Product Innovation Report

Yaw Roller Nut

14 March 2017

1. **Product Innovation Summary:** Yaw Roller Nut, eliminates failure mode resulting from imperfect wrench-turning technique.

Installation

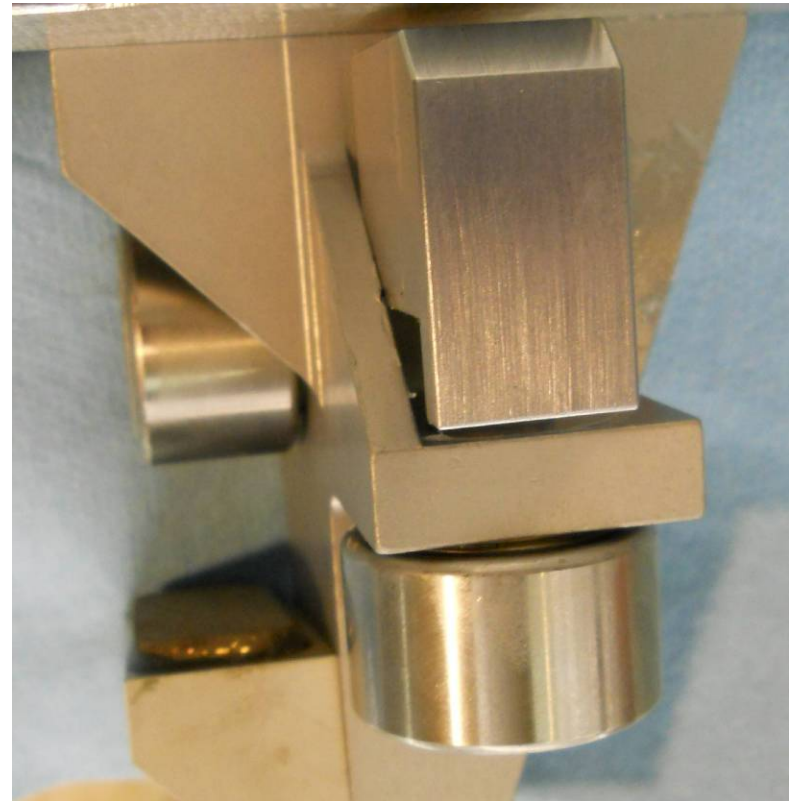
In both cases, stud is turned from below using hex key;
both nuts have corrosion resistant locking feature

Baseline; careful, 2-wrench technique
is required to prevent nut binding

Self-guided yaw roller nut;
second wrench is not required

Rollers Installed

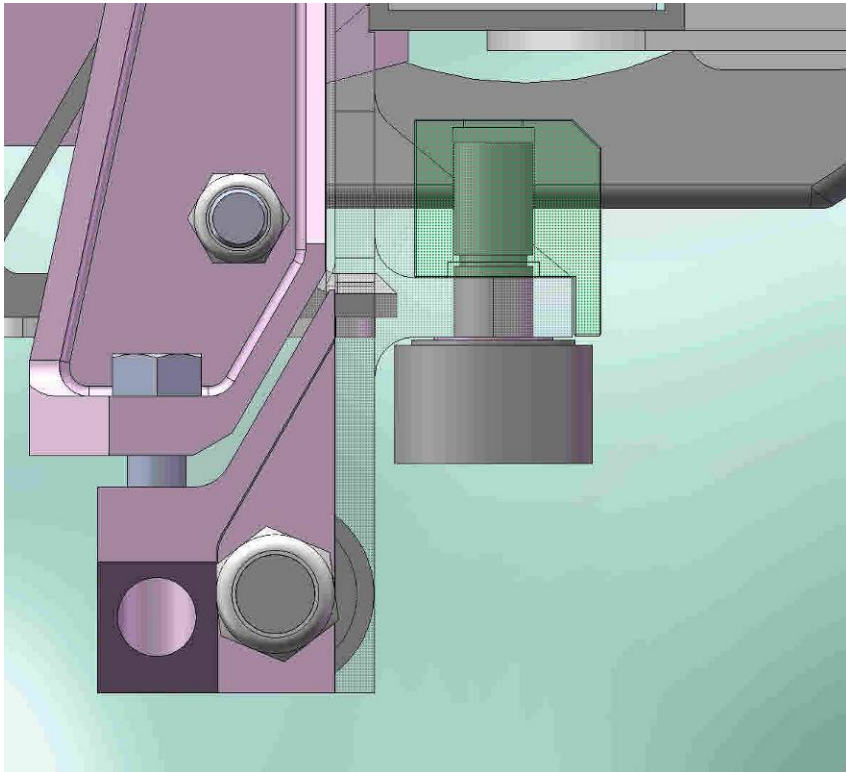
Upgraded configuration with yaw roller nuts on yaw rollers, standard nuts used for pitch restraint; self-locking helical inserts not shown, for simplicity

Rollers Installed

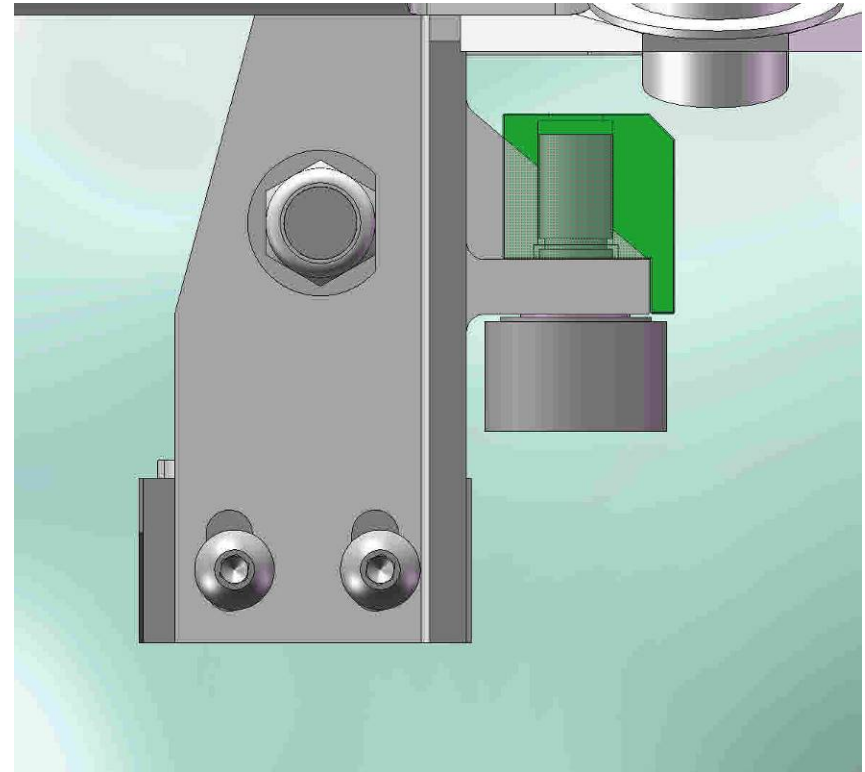
Upgraded configuration

VICD: Spare Roller Assembly

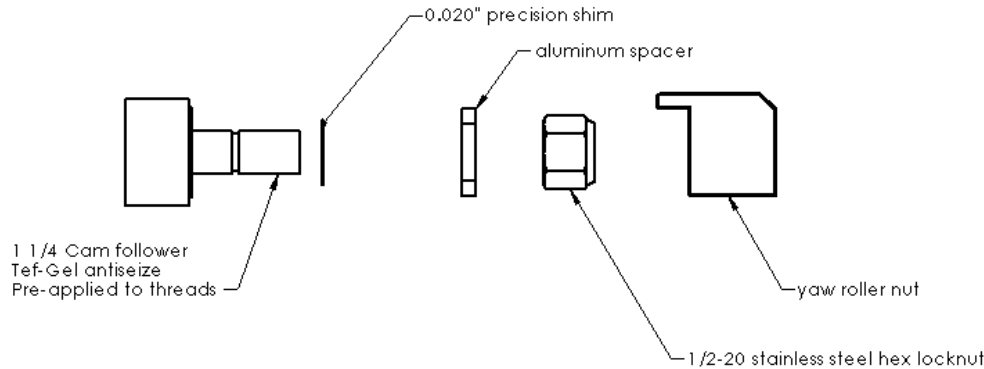
with yaw roller nut included
Revised part #030-030010-000
